MIL-E-62484C(AT)
AMENDMENT 2
17 April 1992
SUPERSEDING
AMENDMENT 1
17 June 1991

MILITARY SPECIFICATION

EARTHMOVER, ARMORED COMBAT, M9
PROCESSING FOR SHIPMENT AND STORAGE OF

FIGURE 6. Protective plywood detail.

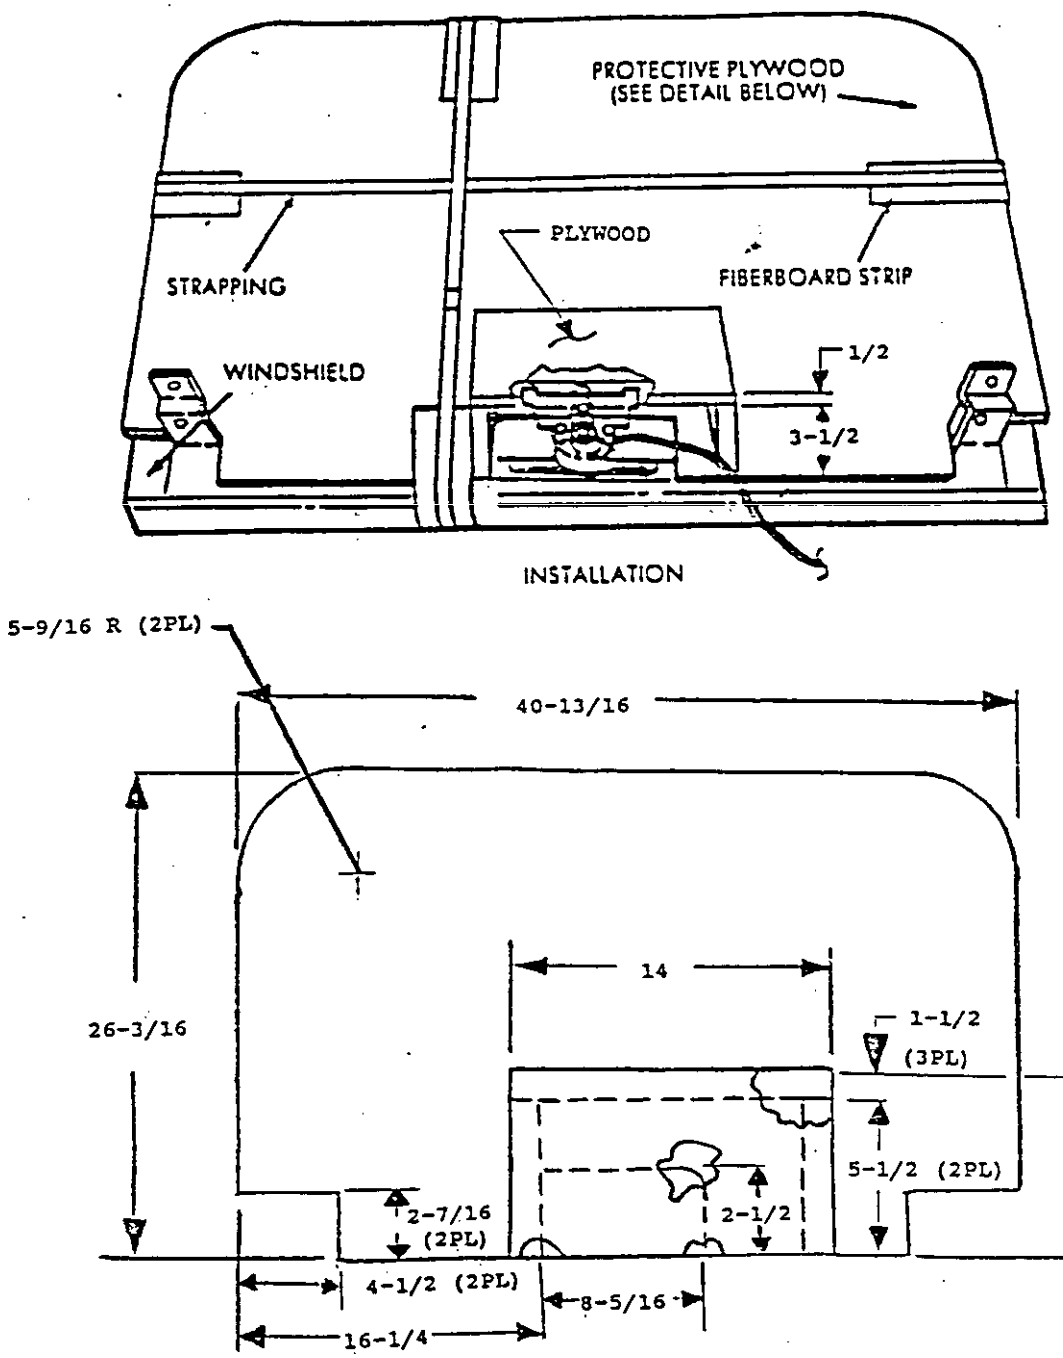
3.4.1.3.6 Windshield and motor. The windshield and motor shall be protected with plywood conforming to NN-P-530. Plywood shall be of ½ inch thickness and shall be suitable for exterior exposure. The cover shall be secured to the windshield and motor with strapping conforming to Type I, Finish B, 3/4 X 0.035 inches of QQ-S-781. Fiberboard strips, Class WR shall be placed between the windshield and the strapping. The windshield shall be secured in the down position (see figure 6).
